From: Michael Stephenson <mstephenson@cameron-cole.com>
Sent: Wednesday, July 23, 2014 5:08 PM
To: Jump, Christine; SMITH, MARTIN L
Cc: Akhter Hossain
Subject: RE: Reporting Limits and Detection Limits table
Attachments: 1808-Soil-Metals.pdf

From: Jump, Christine [mailto:Jump.Chris@epa.gov]
Sent: Monday, July 07, 2014 1:12 PM
To: Michael Stephenson; SMITH, MARTIN L
Cc: Akhter Hossain
Subject: Reporting Limits and Detection Limits table

SOIL METALS SAMPLING LOCATIONS
and IAO EXCEEDANCES
CLEAN HARBORS KANSAS, LLC

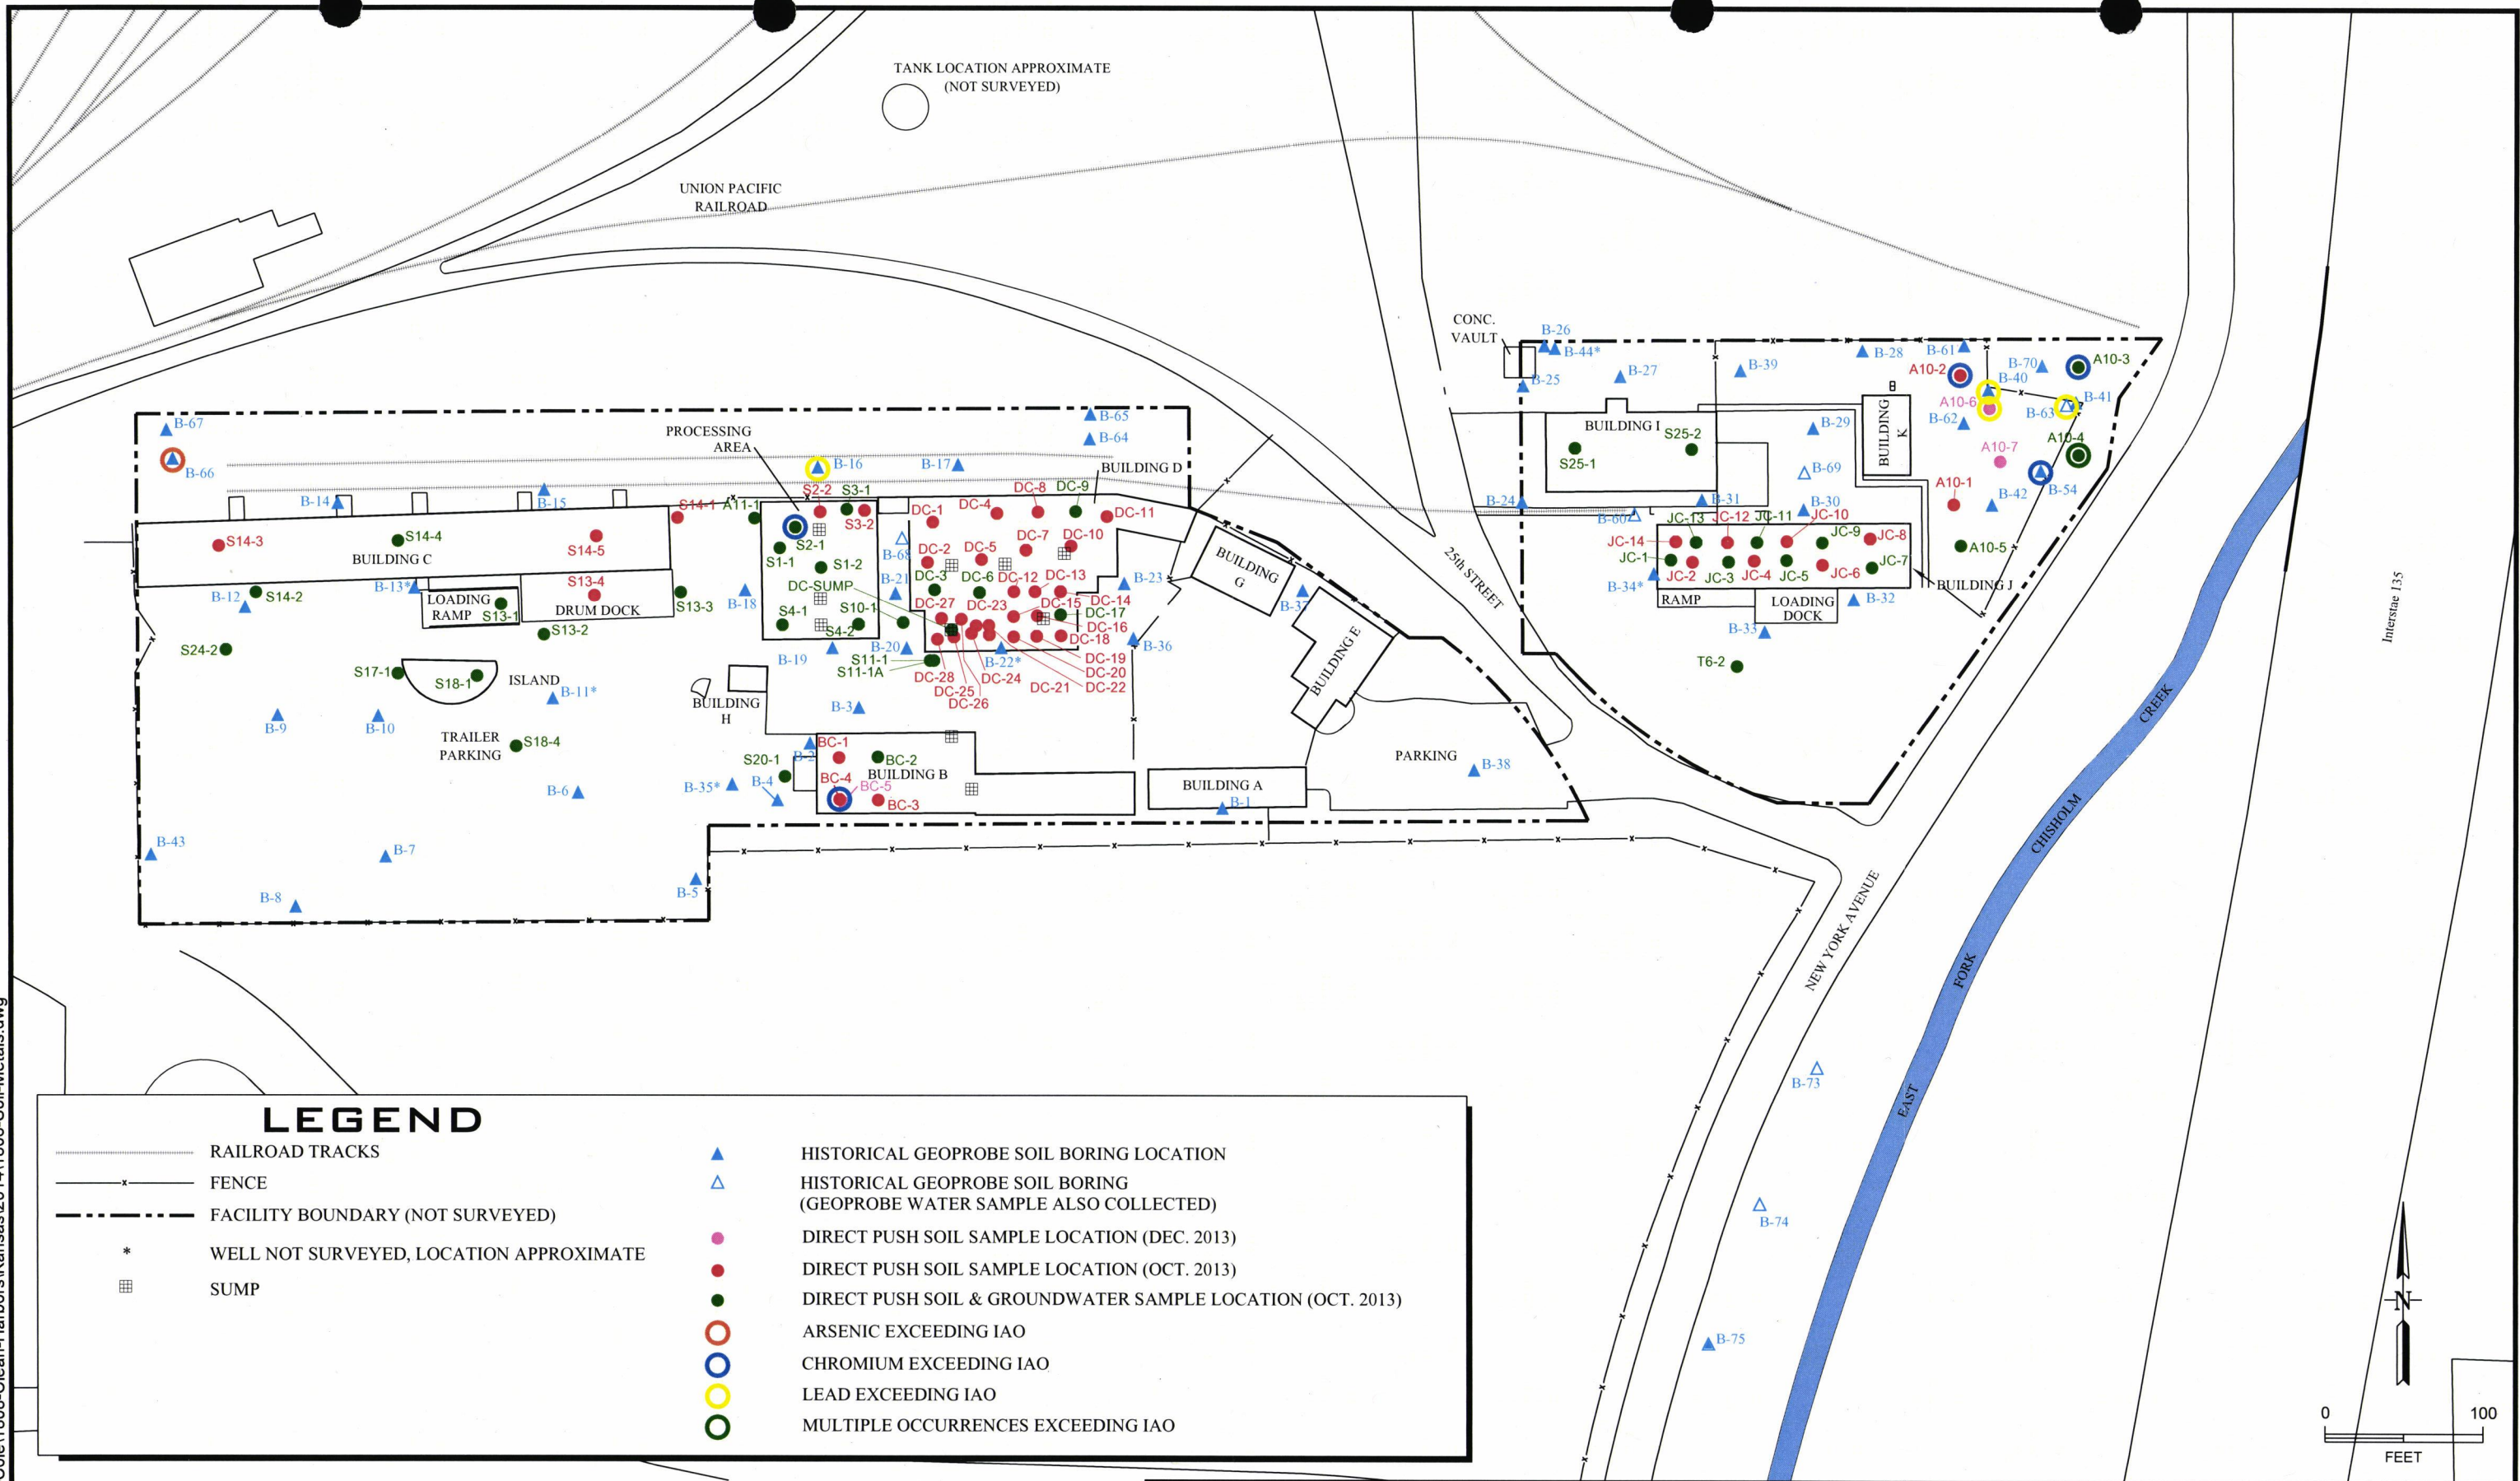
- 1) In the notes, RL is defined as the Reporting Limit. In a previous conversation, you told me that the RL for this project would also be the Quantitation Limit. (QL). This needs to be stated or included in the definition of RL, since RLs may vary depending on the Lab or at a clients' request.

- 2) 1,4-Dioxane does not appear to be included on this table, and must be added.
- 3) There are a lot of NAs listed as the IAO on this table. NA is not defined in the table and EPA does not believe NA is an appropriate Interim Action Objective. EPA realizes that many of the compounds with the NAs were not detected during the RFI phases, however, detection levels and required analyses varied between phases and that is not a guarantee that those compounds will not be detected during the closure sampling. It is EPA's understanding that the compounds with NAs were not listed in the KDHR RSK manual; however, many of those chemicals are listed in the EPA RSL tables. Please propose an IAO for these compounds or propose a method of determining an IAO.

- 4) The table states, "Other compounds to be analyzed at a frequency of 10% of the total VOC analyses, where specified." Since elevated metals have been detected in several locations across the site, EPA will require that metals be analyzed at the same frequency as VOCs.
